Re: **Southton Park (Amending)**

UD/MDP # 002-07-B

The City Staff Development Review Committee has reviewed Southton Park Urban Development Plan/Master Development Plan Amendment (**UD/MDP # 002-07-B**). Please find enclosed a signed copy for your files. Your plan was approved for acceptance, however please note the following:

SE LOOP 410 SOUTHTON PARK, L.L.C.
SOUTHTON PARK MASTER DEVELOPMENT PLAN
 71,931 ACRES TRACT OF LAND BEING TOGETHER WITH THE 1,538 ACRES TRACT OF LAND BEING TOGETHER WITH THE 991 ACRES TRACT OF LAND BEING TOGETHER WITH THE 57,680 ACRES TRACT OF LAND BEING TOGETHER WITH THE 53,518 ACRES OF BLOCK 5160 AND NEW CITY BLOCK 10915 SAID 57,680 ACRES BEING THE SAME AS THE 53,518 ACRES OF LAND AND A 4,186 ACRES OF LAND RECORDED IN VOLUME 6869 PAGE 109 OF THE OFFICIAL PUBLIC RECORDS OF BEXAR COUNTY TEXAS AND NEW CITY BLOCK 10915 SAID 13,551 ACRES OF LAND BEING THE SAME AS THE 13,551 ACRES OF LAND RECORDED IN VOLUME 7391, PAGE 361 OF THE OFFICIAL PUBLIC RECORDS OF BEXAR COUNTY, TEXAS.

MDP #002-07B

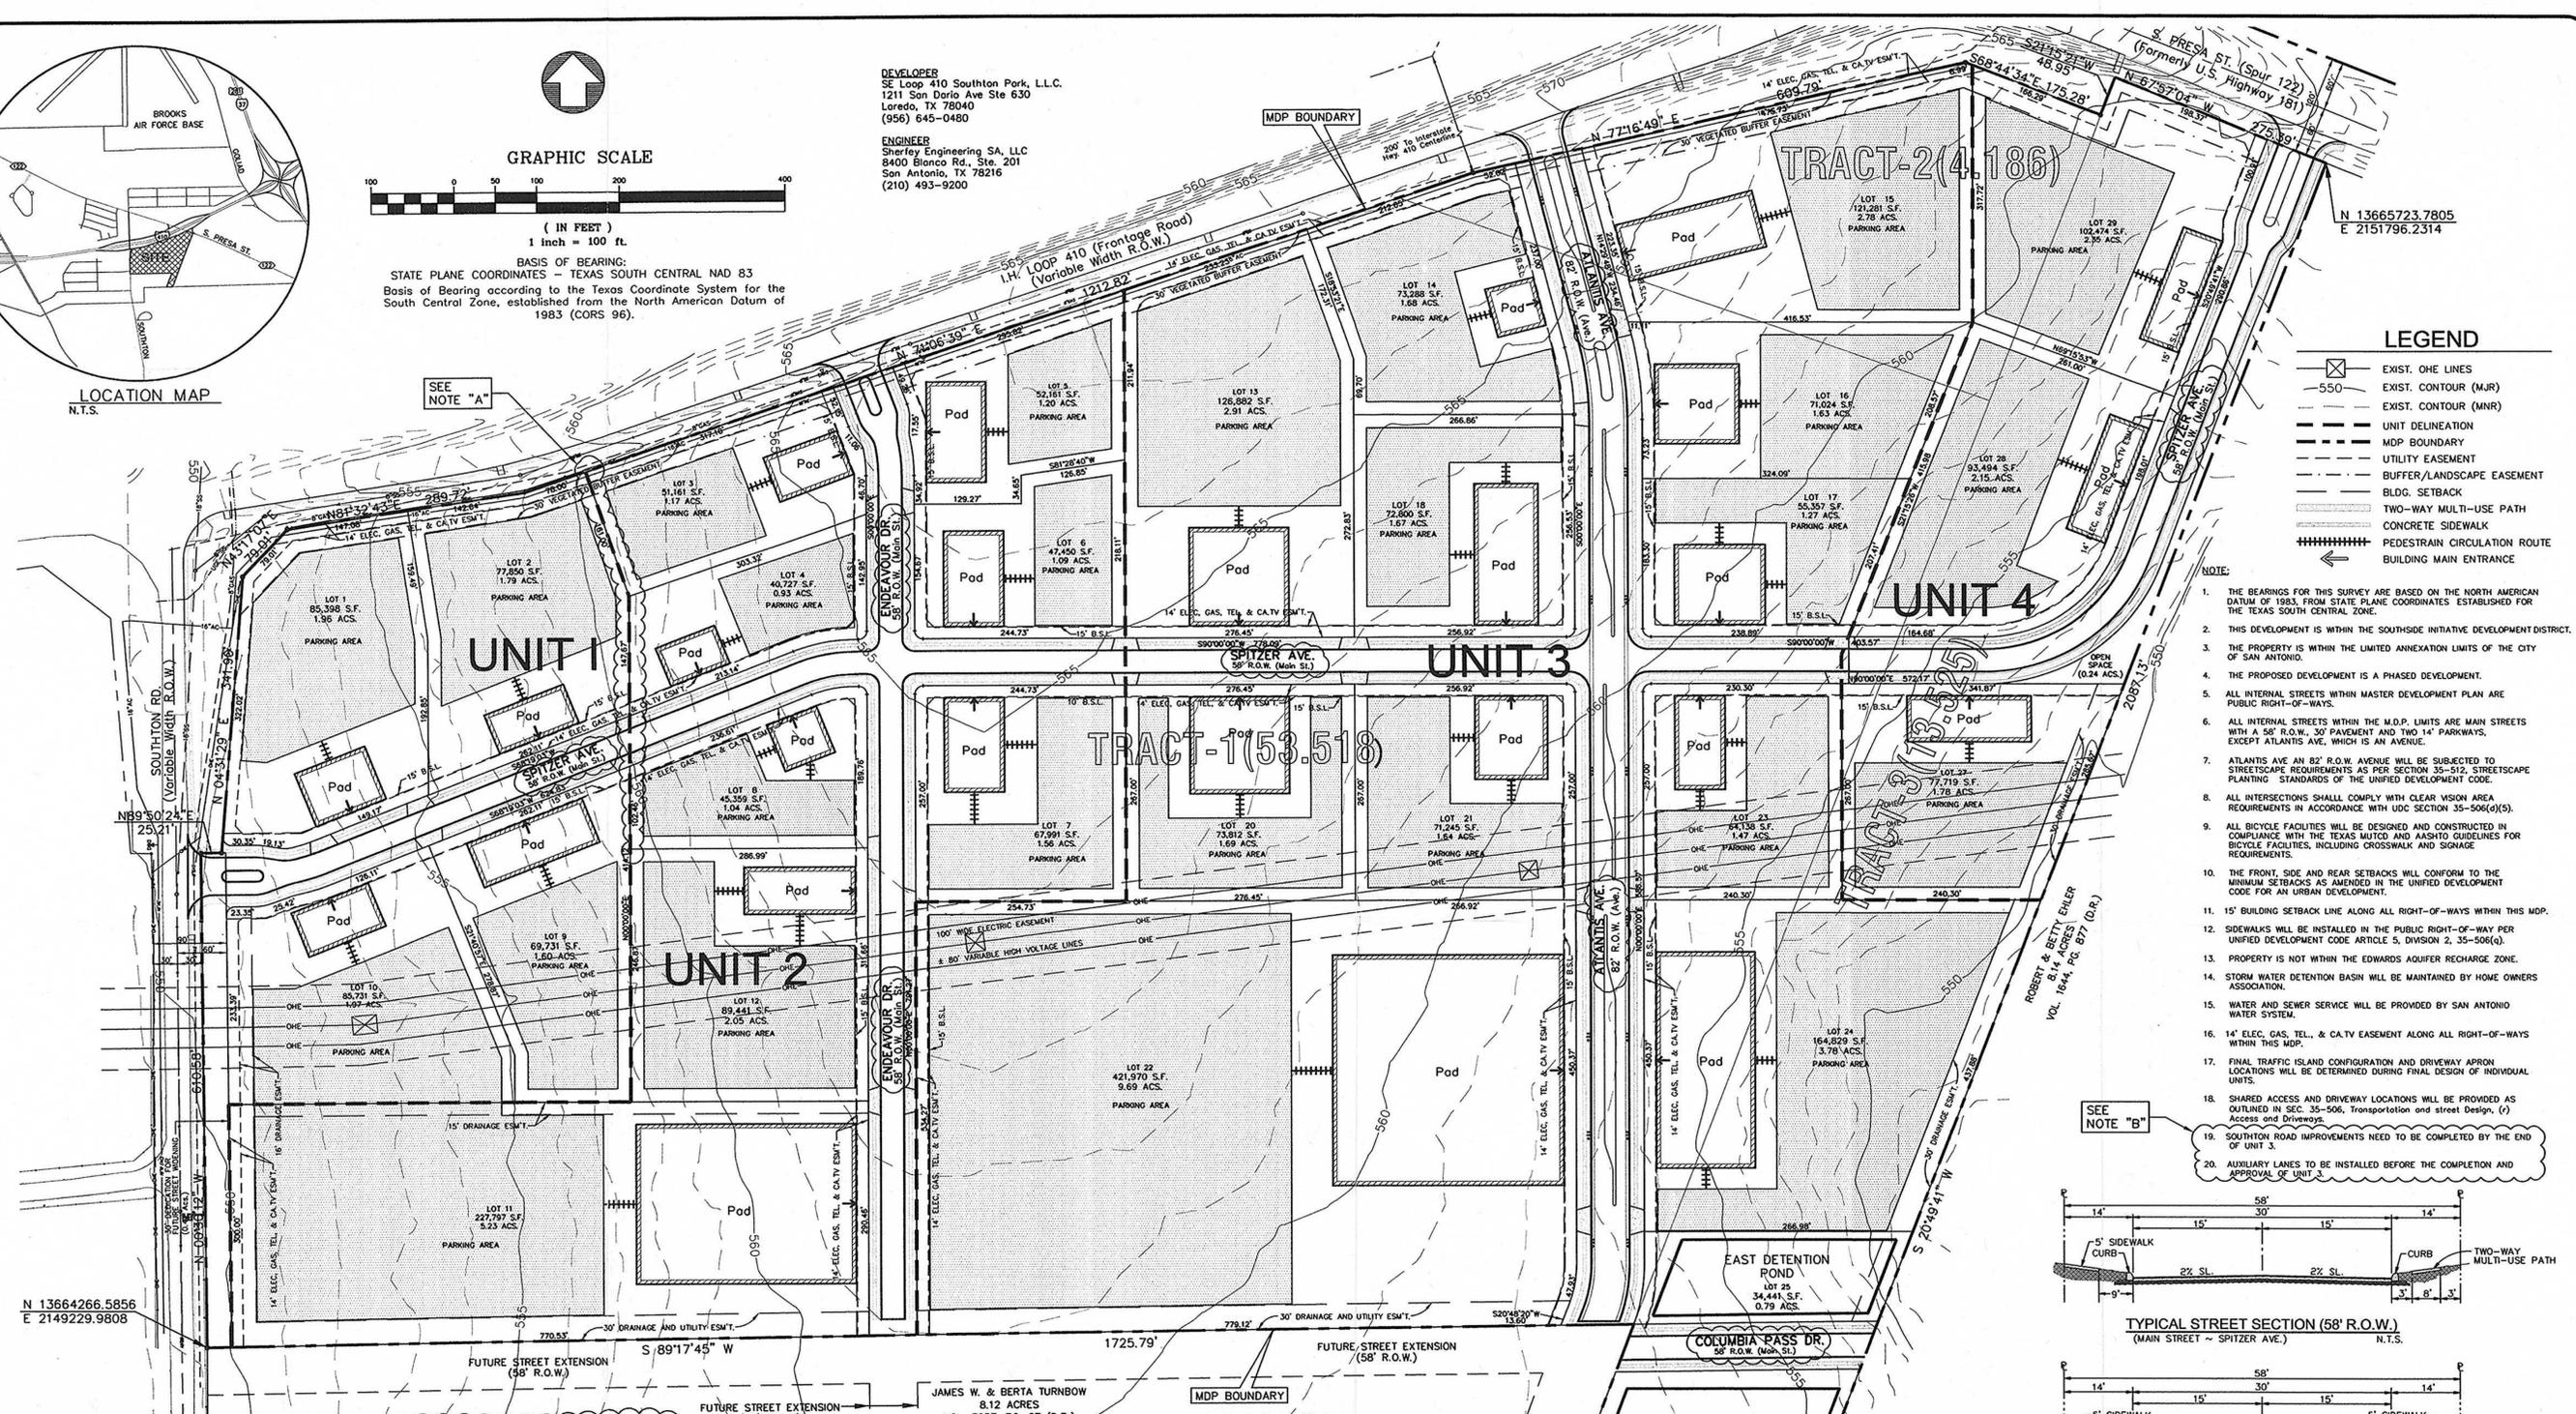
In consideration of public safety and convenience, excessive grades by reason of topography should be avoided in street layouts and arrangements. Any access and R.O.W. issues along state facilities will need to be resolved with the **Texas Department of Transportation (TXDOT)**. For information about these requirements you can contact TXDOT at 615-5814.

Historic Preservation: The Texas Sites Atlas indicates that no archaeological sites have been previously identified within the above referenced property. However, the project area is along the 550' contour of the San Antonio River, an elevation known to contain significant archaeological deposits. Therefore, there is a **high probability** that the property may contain sites, some of which may be significant. An archaeological survey may be necessary at the time of platting.

- Driveway throat lengths shall comply with UDC 35-506, Table 506-7 requirements.
- All commercial driveways for this project shall comply with UDC 35-506, (r) Access and Driveways.

- All access driveways shall provide clear sight distance along all streets surrounding the development to provide adequate obstruction-free viewing distances for approaching traffic. All signage, landscaping, and improvements shall be selected and located so as to not block these clear sight distance areas.

- Southton Road at Proposed Drive A. Provide a SB Southton Road left-turn lane and NB Southton Road right-turn lane for traffic entering Drive A.
- Eastbound IH-410 Frontage at Proposed Drive B. Provide EB IH-410 Frontage Road deceleration/right turn lane for traffic entering Drive B and a right turn/acceleration lane on Northbound Drive B.

- Eastbound IH-410 Frontage at Proposed Drive C. Provide acceleration/deceleration lane on Eastbound IH-410 and a right turn lane on Northbound Drive C., and an acceleration lane for traffic exiting Drive C.

- S. Presa Street at Drive D. Provide a SB Presa Street deceleration/ right-turn lane for traffic turning right into Drive D, a NB Presa Street deceleration/left-turn lane for traffic turning left into Drive D, and a left turn lane for traffic turning right from Drive D into Presa.

- Incorporate traffic control improvements such as signing and pavement markings into the site plan that conform to the Texas Manual on Uniform Traffic Control Devices.

- The developer shall be responsible for providing right-turn deceleration/acceleration lanes and left-turn lanes with storage lengths and bay taper in all street and driveway access points approved by TX DOT as it relates to the submitted TIA traffic counts, as per Unified Development Code (UDC) - 35-502 (a)(7), subsection C.

Tree Preservation: This Master Development Plan meets the criteria of the 2006 Tree Preservation ordinance (Section 35-B125 and Table 35-B101) and is approved with the conditions stated below.

- A Tree Preservation Plan is required prior to any work on site. This can be submitted either as a site work permit or at the platting stage.
- Landscape ordinance per UDC Section 35-511. It appears some landscape points can be met by preserving existing vegetation as well as contributing to mitigation requirements (either through preservation of smaller material or transplanting). Recommend securing knowledgeable Landscape Architect at planning and design phase to better utilize existing trees and vegetation. Preservation will eliminate the need for irrigation.

- Staff would be willing to meet with developer at design stage to assist with tree preservation and landscape plan.
- Streetscape standards per UDC Section 35-512 – Southpark Ave. requires streetscape on the new ROW (recommend preservation of existing trees where available and possible).
